Errata

Applies to IP65 step motors from pilot production build

Eight lead motor connected in PARALLEL to a bipolar drive.

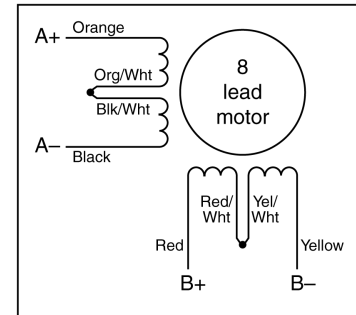
1. Some units have cables that are rated 80°C. These motors should be operated such that the case temperature does not exceed 80°C.
2. The wire colors may differ from our standard. See wiring diagrams below and on the back.

Motors with orange, orange/white, red, red/white, black, black/white, yellow, yellow/white.
